State of Wisconsin \ DEPARTMENT OF NATURAL RESOURCES

Subject: Estabrook Dam, FF#40.08, Inspection Report

Name of Dam: ESTABROOK DAM Date: 10-27-2004
 Inspectors: MJR & WDS F.F.#: 40.08
 Owner's Name: MILWAUKEE COUNTY Key Seq #: 857

SKETCH

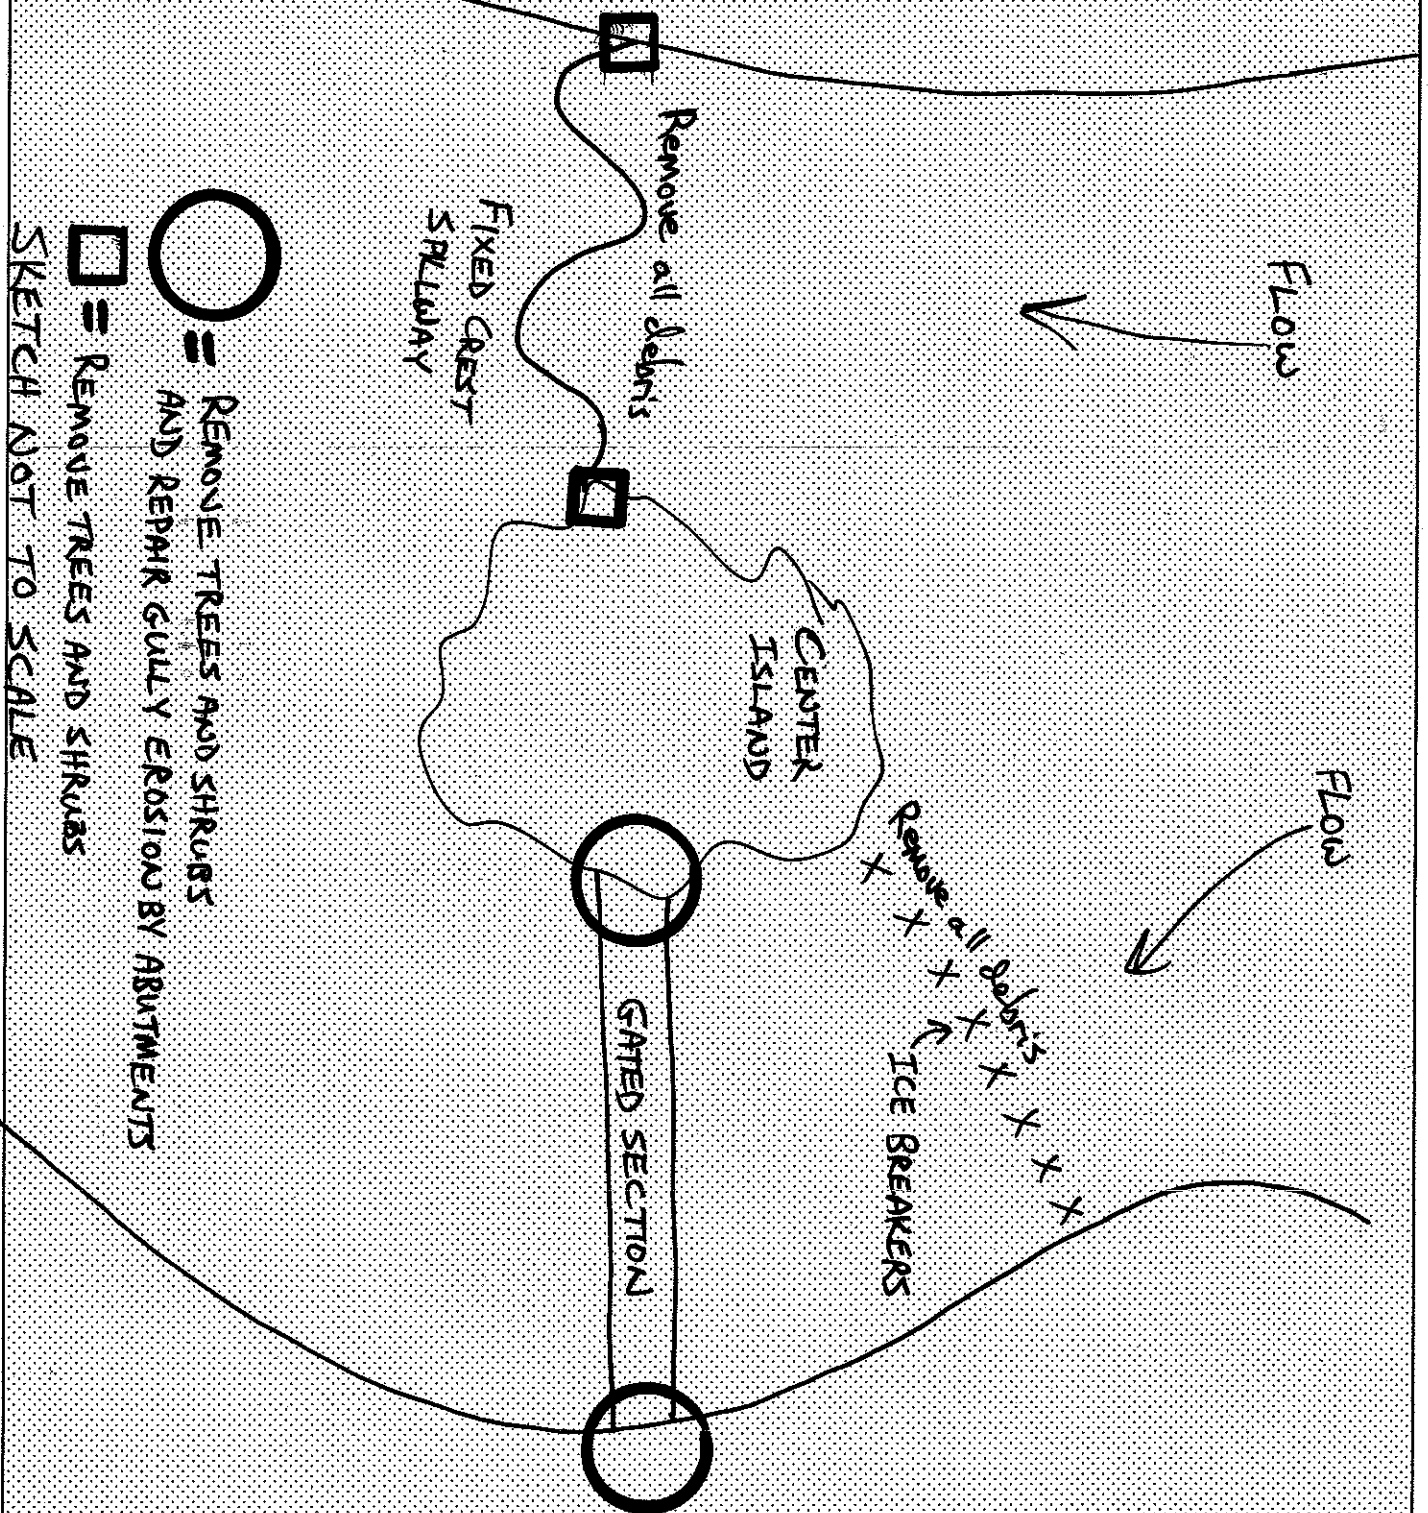
- 8) There are cracks in the structure of the gate section of the dam need further evaluation (See photo #11). The location of these cracks was noted on page of the attached inspection report. The structural integrity of the dam must be evaluated by a structural engineer. A structural analysis needs to be done by December 31, 2005 (see #4 for more information).

There are cracks in the structure in these locations on multiple supports in the gate section. Need to be evaluated by a structural engineer.
